Technical Service Bulletin (TSB)

Mis-Installed 3-way Coolant Valve

REFERENCE:	TSB : 07-006-23 GROUP 07 - Cooling	Date:	May 13, 2023	REVISION:	_
VEHICLES AFFECTED:	022 (JL) Jeep Wrangler PHEV his bulletin applies to vehicles built on June 4, 2022 (MDH 0604XX) quipped with the 2.0L I4 DOHC DI TURBO PHEV Engine (Sales Code CX).		MARKET AF	PPLICABILITY: □MEA □IAP □CH	
CUSTOMER SYMPTOM: The customer may experience a Malfunction Indicator Lamp (MIL) illumination. Upon further investigation the technician may find the following Diagnostic Trouble Code (DTC): P0E80-00 - Coolant Bypass Valve "B" Control Stuck Closed. Customer may also experience the following: Intermittent no heat. 					
CAUSE:	Mis-routed three way coolant valve hos	es.

Fig. 3 Correct Hose Locations

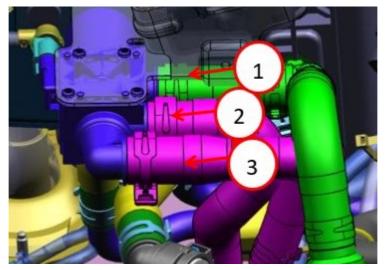
2. Inspect the hose routing. Hose number one should be at the top of the valve: (Fig. 1) , (Fig. 2) , (Fig. 3) .

NOTE: The bottom two hoses should route coolant back to the dash and continue to run parallel and not cross each other.

- 3. Are the three way hoses routed incorrectly?
 - YES>>> Proceed to Step 1 of the Repair Procedure.
 - NO>>> This bulletin has been completed. Use Inspect LOP (07-46-01-90) to close this active RSU. Normal diagnosis should be performed.

Fig. 4 Hose Alignment Marks

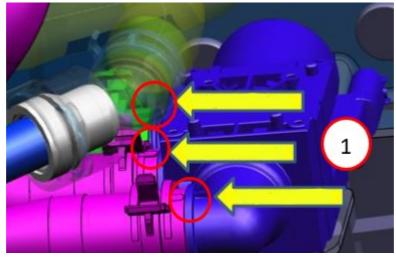
- 1. Drain the high temperature cooling system. Refer to the detailed service procedures listed in DealerCONNECT>Service Library under: 07 Cooling / Standard Procedure (Draining).
- 2. Using hose clamp pliers, Remove the incorrect hoses from the Three Way Coolant Valve.
- 3. Install the hoses to the correct coolant valve ports. Use the hose alignment marks on the backside of the three way valve to confirm each hose is orientated correctly (Fig. 4).

- 4. Refill coolant and inspect for leaks.
- 5. Clear all DTCs that have been set in any module.
